UNITED STATES PATENT AND TRADEMARK OFFICE

Office Action Summary	Application No. 10/766,519	Applicant(s) RONKKO ET AL.	
	Examiner LUN-YI LAO	Art Unit 2629

DETAILED ACTION

Fig. 6a

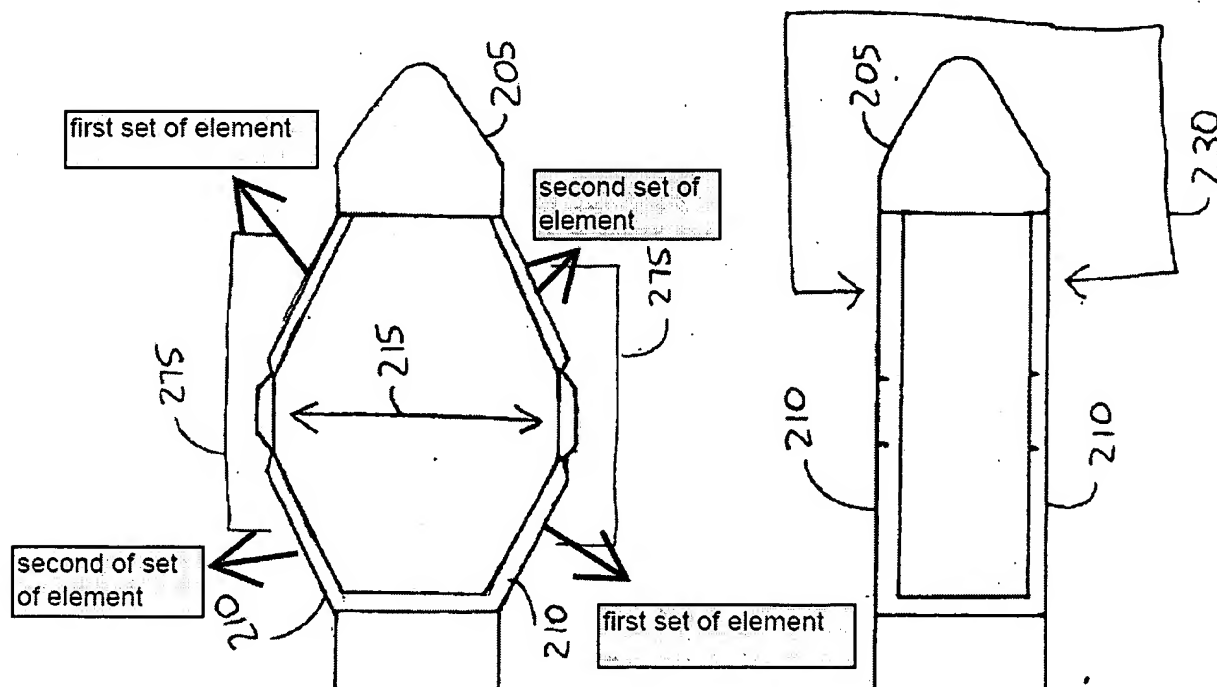
As to claims 15-18, Lilenfeld teaches the plurality of elements comprises at least two sets of elements, the elements(215) of each set being substantially mutually parallel to each other, in both an extended configuration of the stylus and a storage configuration of the stylus(see figures 3, 6a-6b; column 5, lines 58-68 and column 6, lines 1-6).

Applicants argue that Lilenfeld do not teach an accordion-style extendable instrument on page 5. The examiner disagrees with that since Lilenfeld teaches an accordion-style extendable instrument(see figures 6a-7b) and the definition of "accordion" is having a fold or folds like the bellows of an accordion(see <http://dictionary.reference.com/>).

Applicants argue that Lilienfeld do not teach at least one additional hinge or joint on page 5. The examiner disagrees with that since Lilienfeld teach one additional hinge or joint(see figures 3, 6a; column 5, lines 3-11; column 7, lines 45-52 and claim 5).
